Industry-NRC Meeting CASS Screening Criteria for Thermal and Irradiation Embrittlement for BWR and PWR Internals

July 15, 2014
NRC Offices
Washington, DC

Comments on NRC Proposed CASS Screening Criteria for Thermal and Irradiation Embrittlement

Example: Embrittlement in Lower Core Support Columns

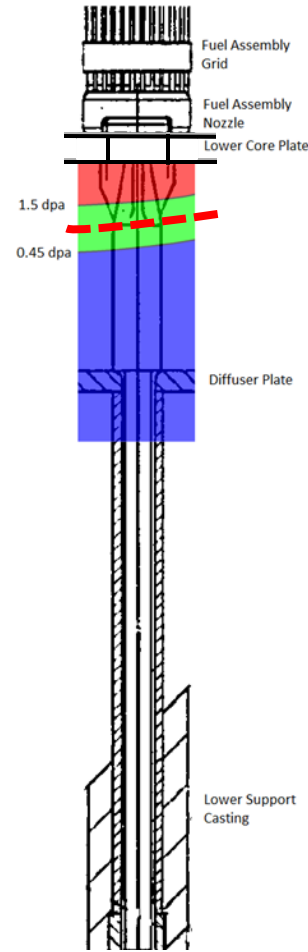
NRC Proposal

62/68 Columns

- Ferrite <15%
- IE in Red
- No Embrittlement - Green, Blue & Below

6/68 Columns

- 15% < Ferrite <20%
- IE + TE in Red & Green

Industry Proposal

68/68 Columns

- Ferrite <20%
- IE Above Dashed Line
- No Embrittlement - Below Dashed Line

Figure 1 - NUREG/CR-4513 Lower Bound J-R Curves for 10-15% Ferrite Showing Margin Above 255 kJ/m² at 2.5 mm for CF-3 and CF-8

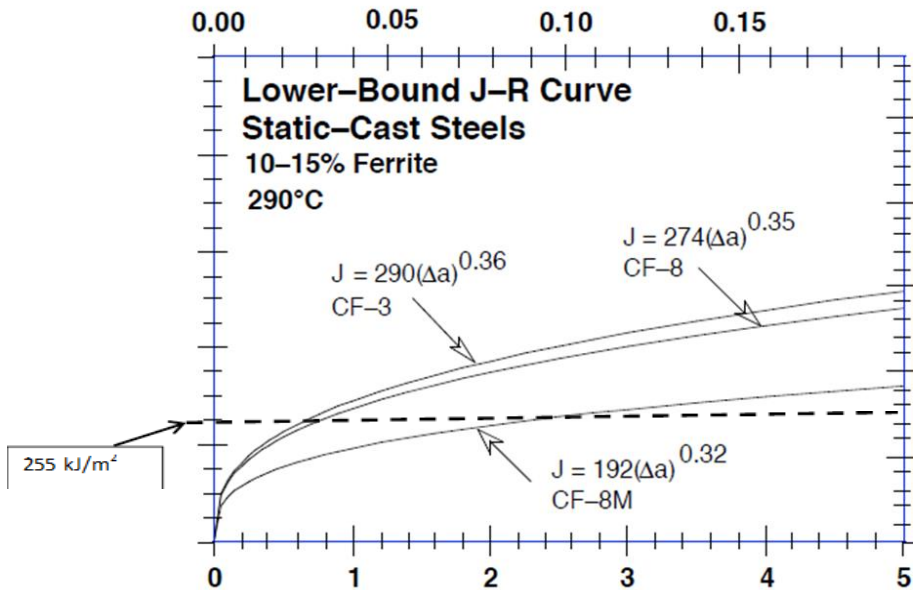
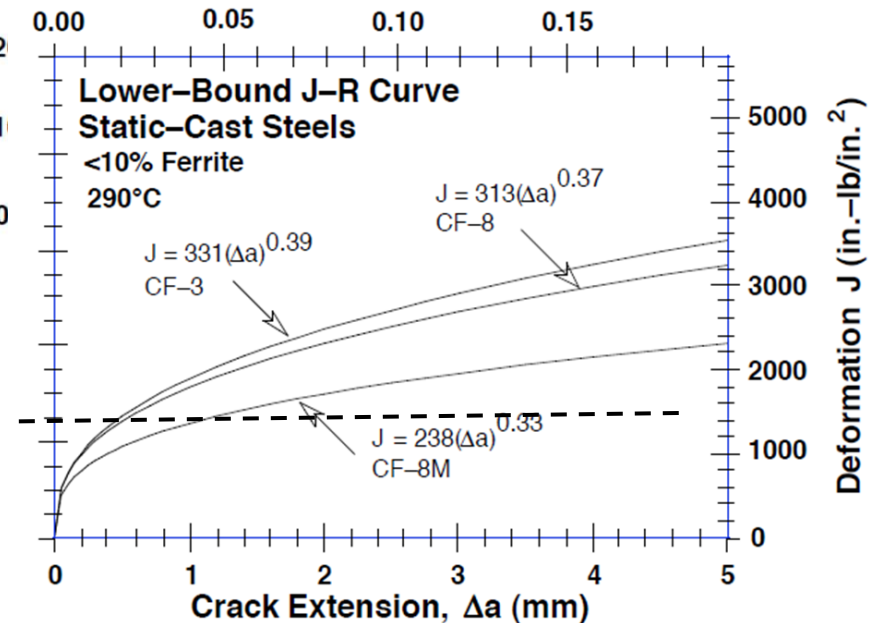
Request Technical Basis for Lower Ferrite Screening Levels in Proposed NRC Guidance

The “NRC staff’s position” section also notes that the staff applies criteria to two different ferrite screening levels depending on neutron “exposure”. The staff suggests changing the ferrite screening to the levels described in NUREG/CR-4513, Rev. 1 (10% and 15% ferrite) from the current ferrite screening levels (14% and 20%) accepted both by the staff and industry for license renewal (e.g., the Grimes letter, MRP-175, and MRP-227-A) without a described technical basis. The basis data for the 14% and 20% screening levels of ferrite are established in industry documentation that clearly states the conservatism used in determining these values and thus it is not clear why additional conservatism (i.e., decreasing the ferrite screening levels to 10% and 15%) is required.

Basis for Reduced Ferrite Screening Levels at > 0.45 dpa

- NRC reduced ferrite content
 - Accounts for uncertainty of end state toughness due to IE+TE
 - NUREG/CR-4513 J-R curves for TE alone show significant margin above 255 kJ/m² at 2.5 mm crack extension at:
 - 10-15% ferrite for low-moly
 - $<10\%$ ferrite for high-moly
- This provides margin for uncertainty wrt additional embrittlement due to fluence

See Figure 1 below for an illustration of the principle. The figure shows there is considerable margin for the lower bound curves for CF-3 and CF-8 above the 255 kJ/m² toughness level at 2.5 mm crack extension. However, for the CF-8M with the same ferrite range, the toughness is right around 255 kJ/m². Therefore, for the CF-8M there is no additional margin for reductions in toughness due to irradiation effects. Figure 2 shows a similar plot for <10 ferrite, which shows even CF-8M has some margin of toughness above 255 kJ/m² at 2.5 mm crack extension.
